ZH3 ASSY P/N :31ZH3MB0008
ZH3 MB C/S ASSY P/N: 41ZH3CS0001
ZH3 MB S/S ASSY P/N: 51ZH3SS0003

PROJECT :ZH3
Quanta Computer Inc.

Change list

IRRX R548 10K 4 +3V

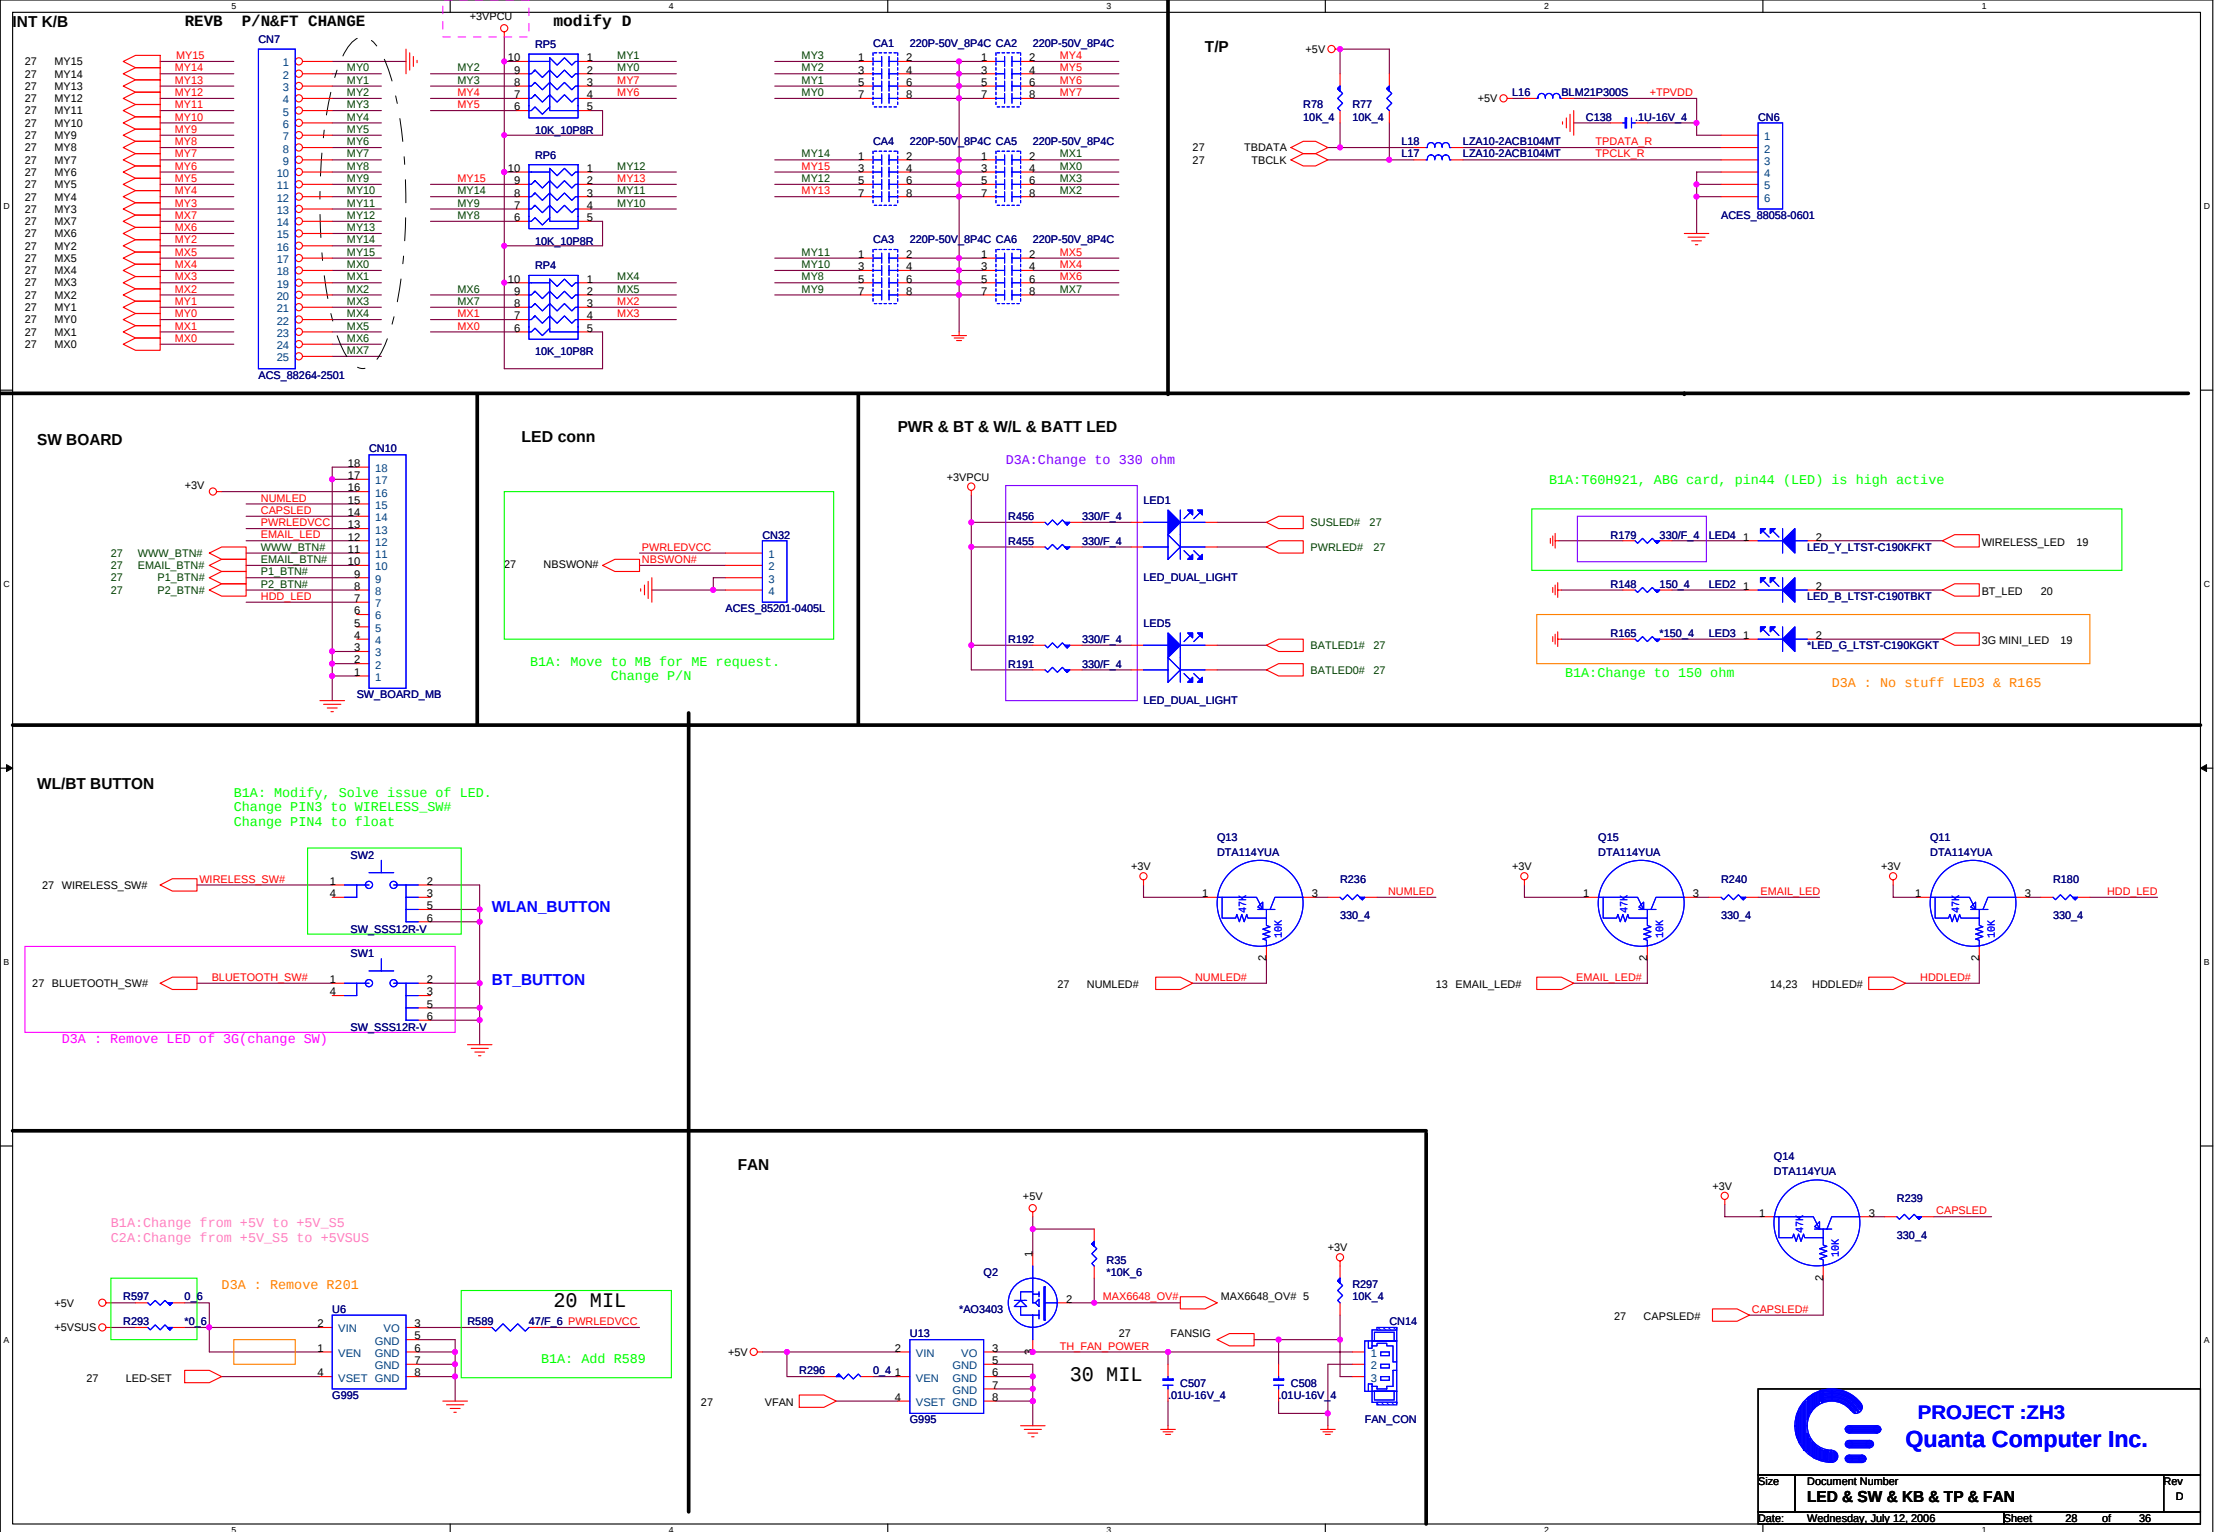
B1A: Stuff R552, set PC87383 I/O to 2E/2F

B1A :Change to 0 ohm

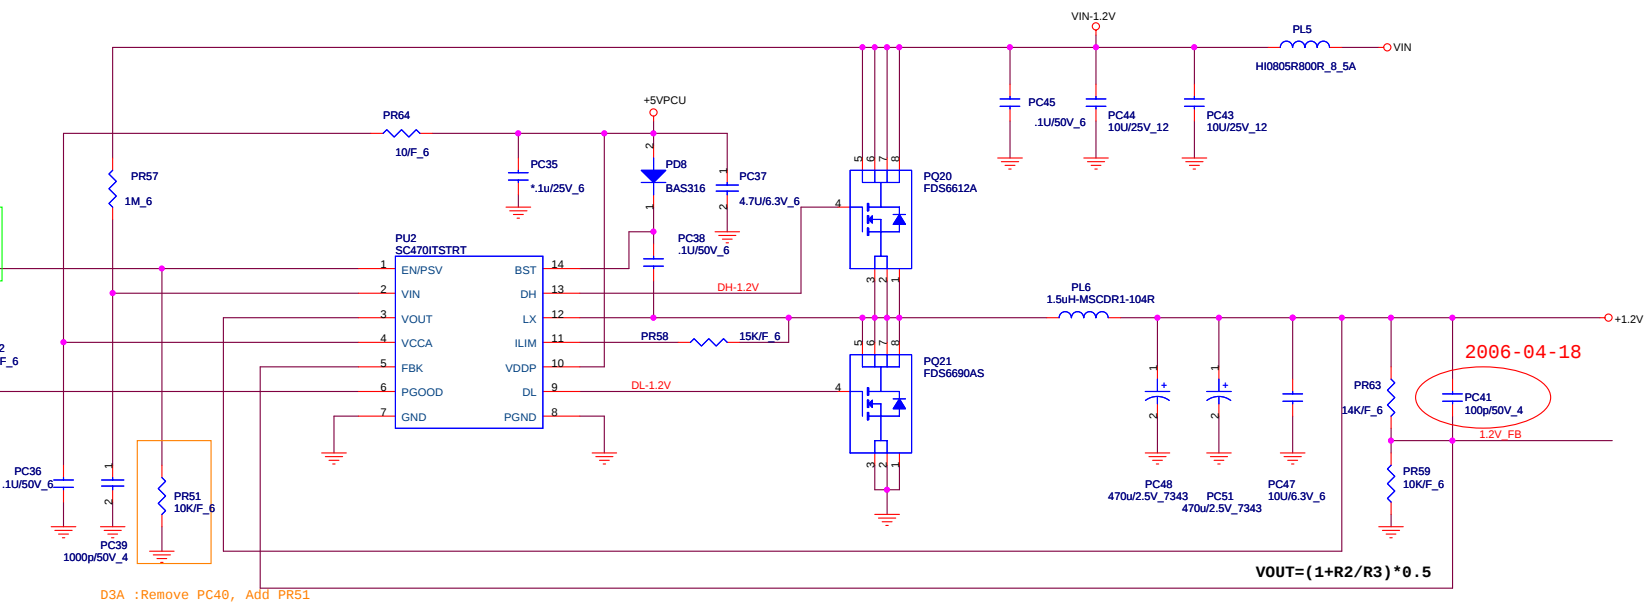
C2A :Modify to EC control ,
Remove PR66, Stuff PR65

D3A :Remove PC49, Add PR51
